ADDENDUM NO. 2 - OUTLINE AND SUMMARY INFORMATION

Project Name: Classroom Improvements 2024-2028 PPA No.: 23-0828
Location: Montana State University, Bozeman Campus Date: January 14, 2025

6 HANDRAIL DETAIL

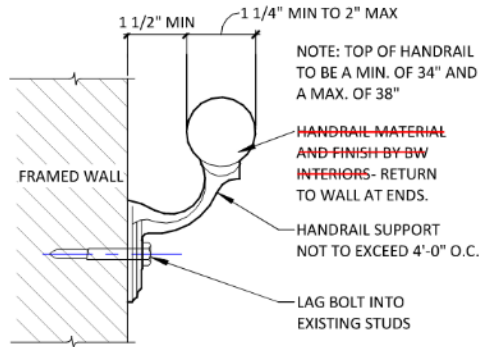
- B. REVISED: Leon Johnson 346 Drawing. Sheet A-211

- C. REVISED: Leon Johnson 346 Drawing. Details 5/A-211, 6/A-211 and 7/A-211. Handrail to be powder coated steel.
- D. REVISED: Leon Johnson 346 Drawing. Sheet AD-101. Existing finish flooring to be removed and disposed of.
- E. REVISED: Cobleigh 429 Drawing. Sheet A-111. Existing finish flooring to be removed and disposed of.
- F. REVISED: Linfield 113 Drawing. Sheet A-111. Existing finish flooring to be removed and disposed of.
- G. REVISED: Roberts 101 Drawing. Sheet AD-111 and Roberts Restroom Sheet A-112. Existing finish flooring to be removed and disposed of.
- H. **THE ONLY FINISH FLOORING TO REMAIN IS IN HERRICK 117.**
